Office Action Summary	Application No. 10/615,133	Applicant(s) O'NEILL ET AL.	
	Examiner Troy Chambers	Art Unit 3641

DETAILED ACTION

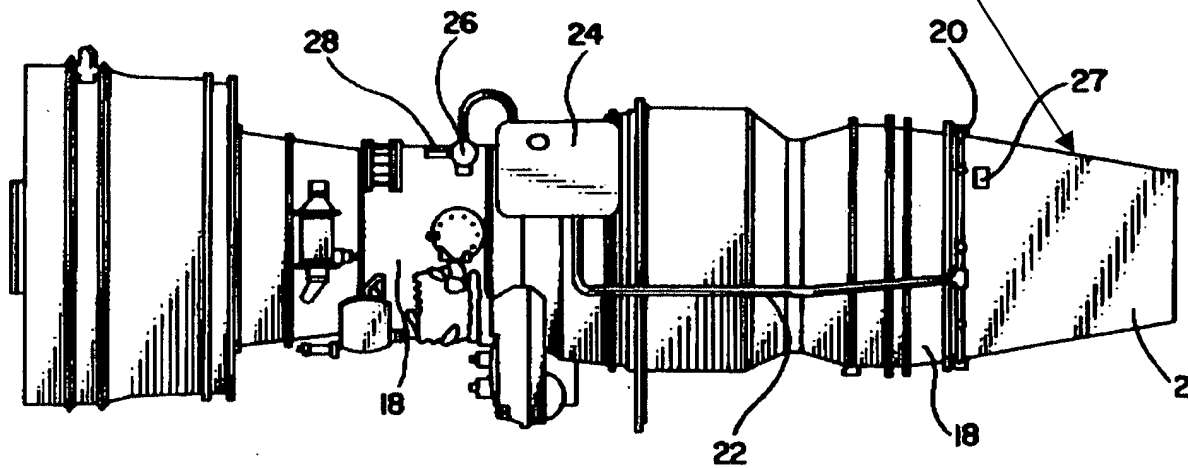
6. Claims 1, 2, 4, 6, 14, 15, 16, 22, 23, 24 and 26 are rejected under 35 USC 102(b) as being anticipated by U.S. 5549259 issued to Herlik. Herlik discloses a method of obscuring an aircraft from infrared detection from an external viewing location. Specifically, Herlik discloses an airtanker comprising a converted A-10 Thunderbolt aircraft for transporting a pilot and fire retardant. The aircraft has two engines as shown in Figs. 1 and 3. The aircraft is provided with a source of obscuring agent comprising water (col. 8, ll. 12-15). The obscuring agent is ejected out of nozzle 9. A viewing location is established within the stream of fluid. A fire can be considered an “attack” on an aircraft due to the heat and dense smoke emanating therefrom which necessitates determining which area of the fire poses the greatest threat and, therefore, should be dealt with first. The fire retardant can be generated on the aircraft (col. 8, ll. 7-16). The A-10 is not disclosed as having an infrared warning system or flares.

Fig. 4

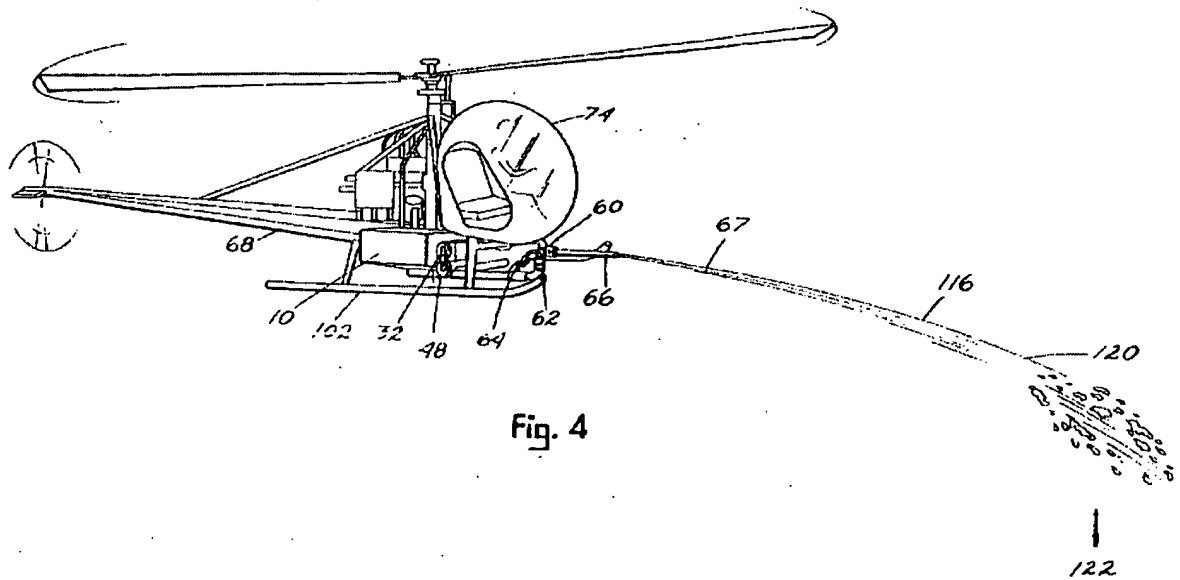
9. Claims 1, 2, 4, 6, 11, 14, 16, 22, 23, 24 and 26 are rejected under 35 USC 102(b) in view of US 4979571 issued to MacDonald. MacDonald discloses a method for obscuring an aircraft from infrared detection. Specifically, MacDonald discloses a foam producing apparatus for fighting fires comprising a helicopter as shown in Fig. 4 for transporting a pilot and fire retardant. A viewer at reference number 122 with infrared capabilities can see the heat given off by the engines of the helicopter. A mixture of CO₂ and water is used to put out fires (col. 6, ll. 41-66) at 122. A viewer at viewing location 122 would have its view of the engine heat (or exhaust plume) obscured by the flow of fire retardant. The obscurant is generated on the aircraft as shown at col. 6, ll. 41-66+. The method is capable of obscuring an auxiliary unit of the helicopter as well as the main engines. There is no disclosure of flares or infrared systems on the helicopter. The retardant is ejected from the front of the helicopter.
